MICREX-F F55 Series Notice of Shape Change of Terminal Block

We would like to thank you for your continued patronage of Fuji Programmable Controllers.
We would like to inform you that Fuji Electric FA has changed the shape of 18-pole terminal block in MICREX-F F55 Series.

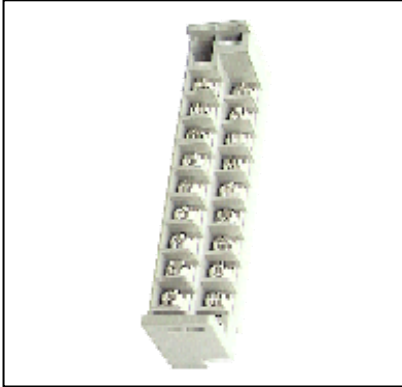
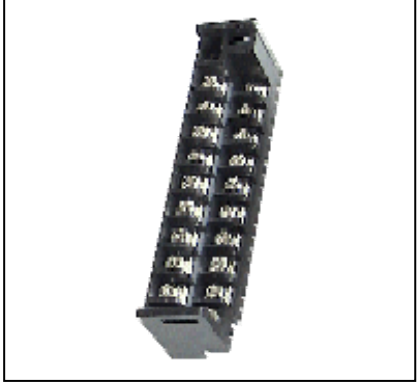
Item	Type targeted	Before change	After change
Change of parts	MICREX-F55 I/O module NV1X0810 NV1X0811 NV1X1604 NV1X1604-W NV1Y08R-00 NV1Y08S NV1Y16R-08 NV1Y16T05P5 NV1Y16U05P5 NV1AX04-MR (including standard-compliant modules)	1. Change of molded resin TUFPET PBT: G2820 Color: Munsell 5Y5/1 	1. Change of molded resin NOVADURAN: 5010GN Color: Black

Change to substitute one along with terminal block molded resin discontinuation
